- Subject : Motor with gear and brake for spindle drive
- Effectivity : DG-400 und DG-800A, LA
- Accomplishment : In case of a defective motor or gear

**Spindelantrieb  
Zusammenstellung  
spindle drive assembly**

4R14

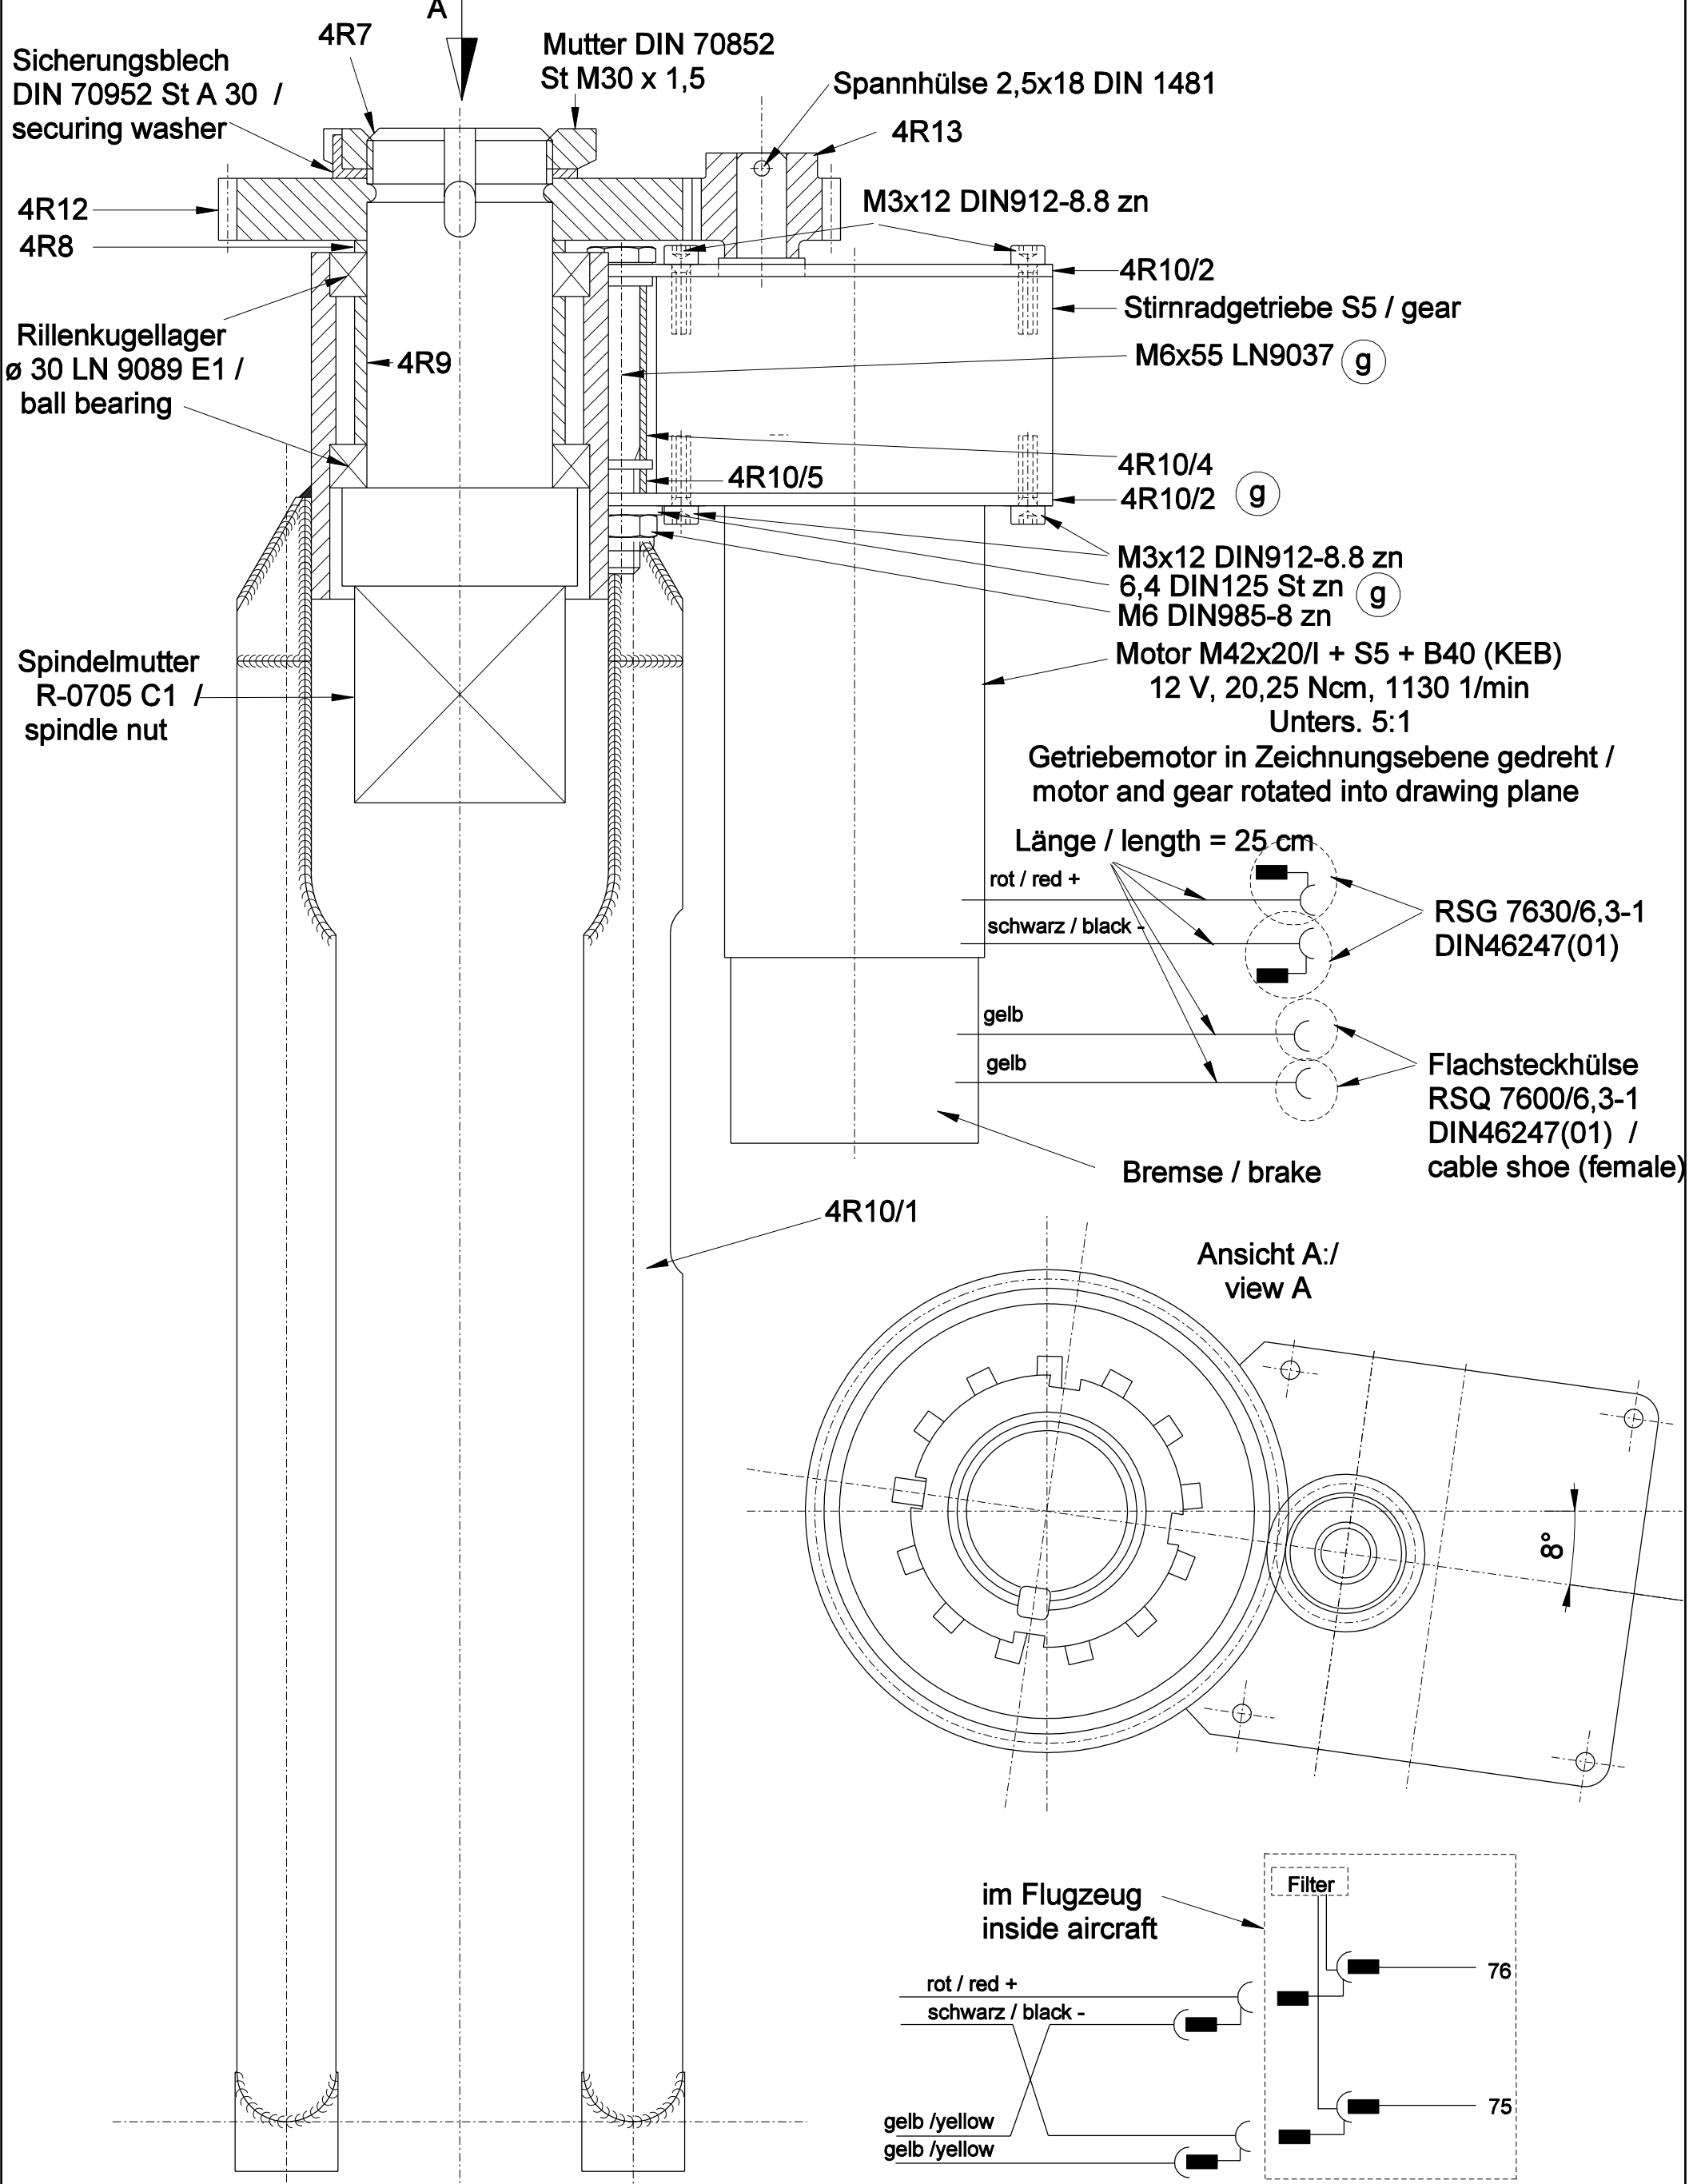
- Reason : The existing motor is no more available. Thus a new design with a newer type of motor was necessary. This motor has different sizes.
- Instructions :

1. Remove the old motor: DG-400 according to maintenance manual section 4.4.1, DG800 according to maintenance manual section 4.14.1.  
2. Install the new motor according to drawing 4R14 issue e.  
2 spacer bushes 4R10/5 are necessary in addition to the fasteners used for the old motor.  
Refer to maintenance manual section 4.4.4 (DG.400) and 4.14.4 (DG-800) for further information.

3. Connect the wiring according to the sketch on drawing 4R14.
- Material : drawing 4R14 issue e  
2 spacer bushes 4R10/5  
1 Motor M42x20/I + S5 + B40 (KEB) 12 V, 20,25 Ncm, 1130 1/min, gear 5:1 assembled with brake, mounting plates 4R10/2, /3 and gear pinio, wiring with terminals  
2 M6x55 LN9037  
2 6,4 DIN125 St zn  
2 M6 DIN985-8 zn

Toleranzen nach Arbeitsanweisung BA 1				
Schweißen nach Arbeitsanweisung SA 1				
g	4R10/3 entfällt, div	9.11.056	W.Dirks	
f	4R13 1 Teil	20.10.06	W.Dirks	
e	neu gezeichnet Getriebemotor neu	01.02.06	Henes	
Ausg	Änderung	AM	Tag	Name
